Re: Pacific Gas and Electric Company's Response to Independent Peer Review Panel Report
Number 10

This letter is to respond to the California Public Utility Commission's (CPUC) Independent Peer Review Panel (IPRP) Report No. 10, "*Preliminary Comments on PG&E's May 2015 Update of the Three-Dimensional Velocity Model for the Diablo Canyon Power Plant Foundation Area and Site Amplification Using Analytical Approach*", herein referred to as "IPRP Report No. 10." This letter also summarizes the additional work performed by Pacific Gas and Electric Company (PG&E) with regard to the site three-dimensional (3-D) velocity model, site amplification, and associated uncertainties that were the subject of IPRP Report Nos. 6 and 9. PG&E herein is providing additional documents and clarifications to the IPRP's specific comments on Ground Motion analysis to support the IPRP's in-depth review.

Figure 3 - Empirical Site Term for DCPD Relative to SWUS Reference Rock

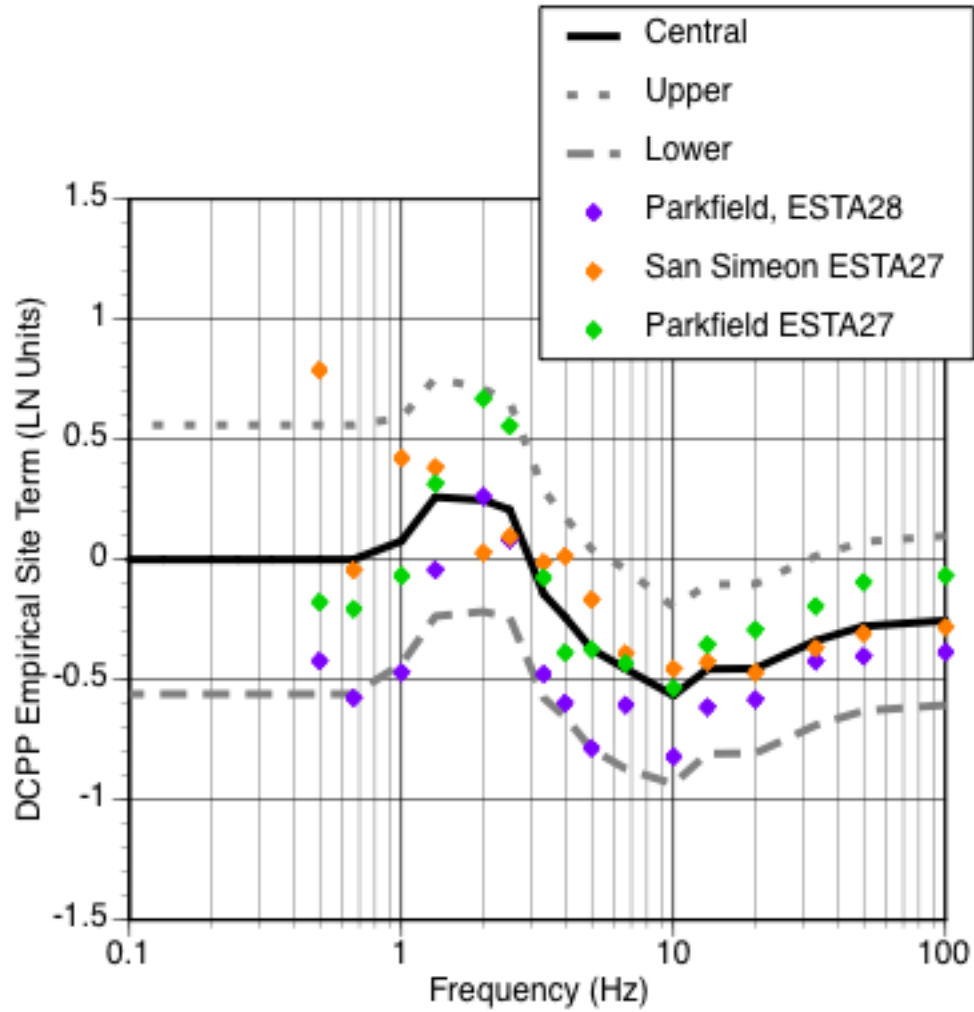
IPRP Comment: IPRP Report No. 10 notes that PG&E used an empirical approach to evaluate local site conditions to either amplify or de-amplify earthquake ground motions to develop the ground motion response spectrum (GMRS) for the PG&E March 2015 submittal to the NRC.

PG&E Response: In response to the NRC RAI, PG&E derived updated amplification factors.² At the request of the NRC, ground motion levels were derived for site conditions that reflect the range of 1-D profiles, extracted from the 3-D velocity model under the Turbine Building and containment structures. These reference site profiles with uncertainty reflect the plant-wide velocities rather than the specific location (ESTA28) as was originally submitted in March 2015. In addition, the site response was computed using both the empirical and analytical methods using a logic tree approach. Uncertainty in the analytical site terms was evaluated using multiple shear-wave velocity profiles, kappa values, and non-linear material models. In the logic tree, the empirical approach was given 2/3 weighting and the analytical approach 1/3 weighting. The higher weighting given to the empirical approach reflects the preference to use empirical data when available over analytical modelling because the empirical approach better captures 3-D velocity structure and representation of the plant region wave propagation effects, whereas the analytical approach reflects the more localized effects of a range of 1-D velocity profiles.

An advantage of the analytical approach is that it allows non-linear site effects to be evaluated. The analytical site response is computed for a range of input ground motion levels. The full range of site amplifications is combined with the reference rock site hazard curves to compute site-specific hazard curves on the surface at DCPD following the methodology in the SPID document. Examples of the analytical amplification factors for two levels of ground motion (peak ground acceleration of 0.2g and 1.07g for the reference rock site with VS30=760 m/s) are shown in Figures 1 and 2. The factors for a peak acceleration of 0.2g represent the linear range applicable to the empirical data. The factors for 1.07g represent the non-linear site effects for a level of shaking corresponding to the 1.0E-4 hazard level. The empirical model and the site amplification data are shown in Figure 3.

Figure 4 - Comparison of the amplification from the empirical and analytical methods. (Heavy Black lines are the empirical results, light grey lines are the analytical results for PGA=1.07g, Heavy green dashed line is the mean for the analytical results for PGA=1.07g.)

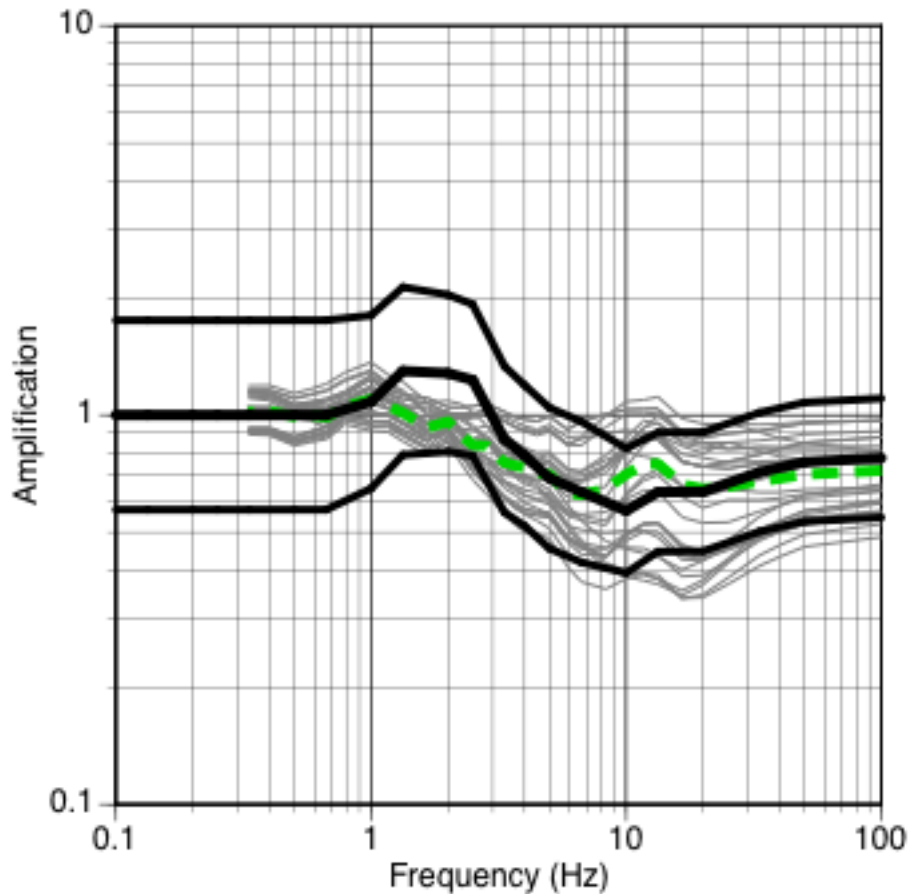
The IPRP had two concerns with the analytical approach: 1) using a broad range of kappa values (0.024s to 0.07s); and 2) using deep 1-D velocity profiles to characterize a site that is spatially complex geologically.

The empirical and analytical site factors are compared in Figure 4. Overall, the results from the empirical and analytical approaches are similar, although there are some differences. The empirical factors show a stronger amplification in the 1 to 3 Hz range which may reflect either deep site amplification or path effects that were not fully removed. The analytical factors show a stronger amplification near 10 Hz which may reflect site resonances due to the use of 1-D velocity models that is not seen in the empirical data.

The general consistency of the empirical factors and the analytical factors shown in Figure 4 indicate that the analytical results based on the 1-D velocity profiles are reasonable and reflect the site amplification in the DCP turbine building and containment structure region.
